### **Meadowbank Dike Review Board Reports**

Report No 20  
Meadowbank Mine Dike Review Board  
Conference call March 23<sup>rd</sup>, 2017

Report No 21  
Meadowbank Mine Dike Review Board  
Meeting July 19, 2017

Report No 22  
Meadowbank Mine Dike Review Board  
Meeting September 4-7, 2017

Photo #1 Stormwater dike

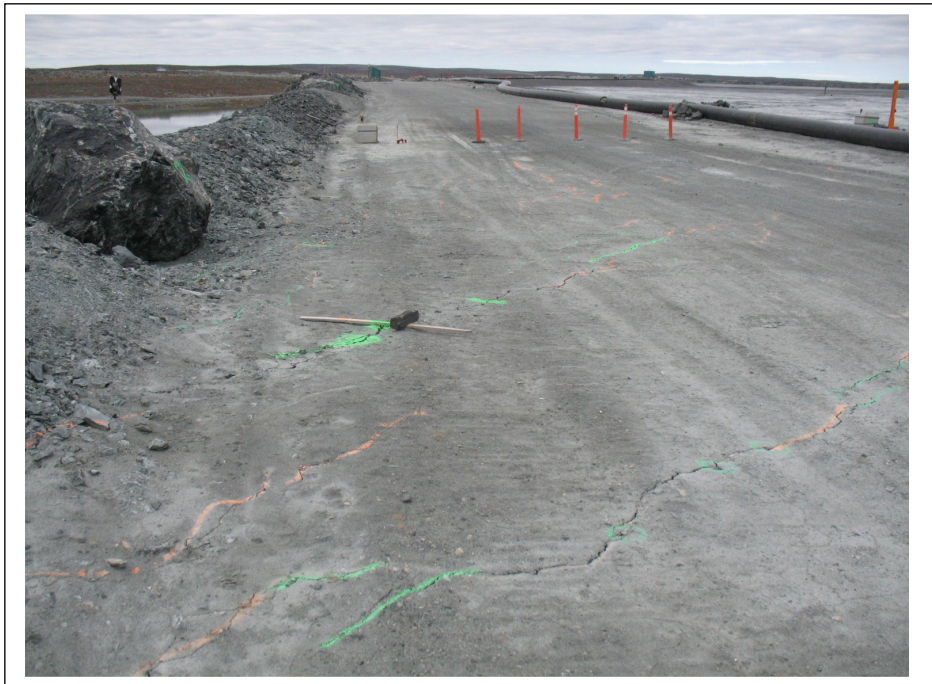
As the South Cell pond level rises (131 m in September 2016, 137 m in September 2017) inundating a greater length of the Stormwater Dike footprint (Photo #1), additional thaw settlement could be expected. This effect has materialized and additional movements and cracking have been observed since July 2017. Settlement at the downstream side of the crest has attained 70 cm (Photo #2), though it is noted that the deformation on the upstream side is considerably less and the integrity of the Coletanche liner is not jeopardized. Furthermore, the tailings deposited in the North Cell adjacent to the liner are now frozen. The area influenced by cracking now extends from Stn. 10+425 to Stn. 11+050. Additional prisms mounted on large boulders (Photo #3) and wire extensometers have been added to complement those installed in 2016.

- the deformation is adequately monitored but monitoring needs to be continued;
- the mechanism is reasonably well understood;
- continuation of movements is to be expected;
- now that most of the toe length is submerged, additional water level rise is likely to be less influential than the effect of time and the available heat flux from the pond water;
- the formation of a tailings beach along the downstream side of the Stormwater Dike would be useful in limiting the heat flux and eventually permitting freeze-back in the area.

In the previous report the Board recommended filling the cracks on the crest with bentonite to prevent ingress of rainwater, it would be advisable to continue this operation for the recent cracks. The finer cracks could be filled with bentonite but the wider ones could be treated with a bentonite-sand mixture to reduce shrinkage. This action would reduce the risk of pressures in the back scarp that could accelerate deformation.
